## Si3402-A-GM to Si3402-B-GM EVB Modifications Version 0.4

Table 1. Si3402-B-GM EVB modifications versus the Si3402-A-GM EVB

Si3402ISO (Flyback, Isolated) EVB Reference Design – 5V

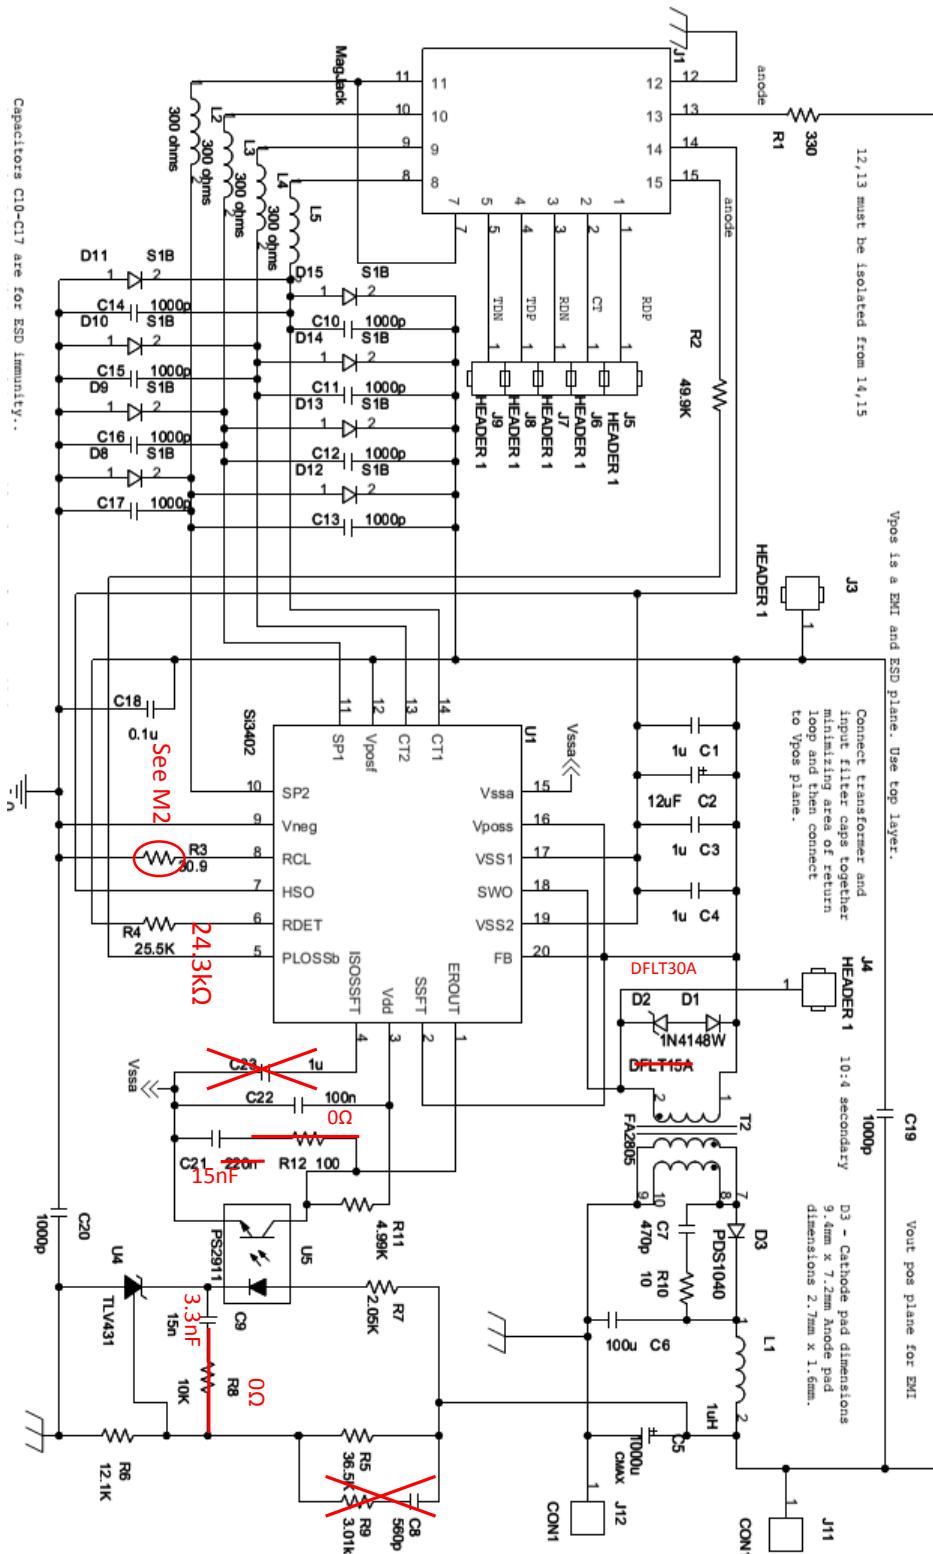
Item	Modification description	Application design effect
M1	Detect resistor value change	The former 25.5kΩ detect resistor must be replaced by 24.3kΩ 1%
M2	Classification resistor value change	The following 1% resistors must be used: Class0: 681.00 or higher (It is optional to place this resistor) Class1: 140.0 Class2: 75.0 Class3: 48.7 Class4: 33.2
M3*	ISO EVB DCDC 3.3V changes Flyback	C8, R9 & C23 are not need—Do not populate them. C9=10nF, C21=33nF, R12=475 Ω & R8=1.1k Ω Replace D2 (DFLT15A) with DFLT30A * See Revision Notes
M4	ISO EVB DCDC 5V changes Flyback	C8, R9 & C23 are not need—Do not populate them. C9=3.3nF, C21=15nF, R12=0 & R8=0 (place zero Ω resistors) Replace D2 (DFLT15A) with DFLT30A
M5	ISO EVB DCDC 12V changes Flyback	C8, R9 & C23 are not need—Do not populate them. C9=10nF, C21=15nF, R12=0, R8=0 (place zero Ω resistor) R7=3k Replace D2 (DFLT15A) with DFLT30A
M6	DCDC reference voltage change (Buck case only)	Now 1.35V instead of previous 1.23V. Thus, R5 changes from 2.87kΩ 1% to 3.24kΩ 1%. R6 (1%) is modified according to this table:

Vout Target	R5 kΩ	R6 kΩ	Vref	Vout Measured
		3.3	3.24	4.64	1.35	3.37
		5	3.24	8.66	1.35	4.96
		9	3.24	18.2	1.35	8.93
		12	3.24	25.5	1.35	11.98
M7	BUCK EVB DCDC 3.3V compensation network changes	C19, C20 & C9 are not need—Do not populate them. R8 can be populated with a 0Ω resistor (creating a short between pins 3 and 4) or left unpopulated, since the ISOSSFT function is now internal (see datasheet). C7=1nF, R7=47kΩ ±20%.				
M8	BUCK EVB DCDC 5V compensation network changes	C19, C20, R8 & C9 are not need—Do not populate them. R8 can be populated with a 0Ω resistor (creating a short between pins 3 and 4) or left unpopulated, since the ISOSSFT function is now internal (see datasheet). C7=1nF, R7=47kΩ ±20%.				
M9	BUCK EVB DCDC 12V compensation network changes	C19, C20, R8 & C9 are not need—Do not populate them. R8 can be populated with a 0Ω resistor (creating a short between pins 3 and 4) or left unpopulated, since the ISOSSFT function is now internal (see datasheet). C7=1nF, R7=47kΩ ±20%.
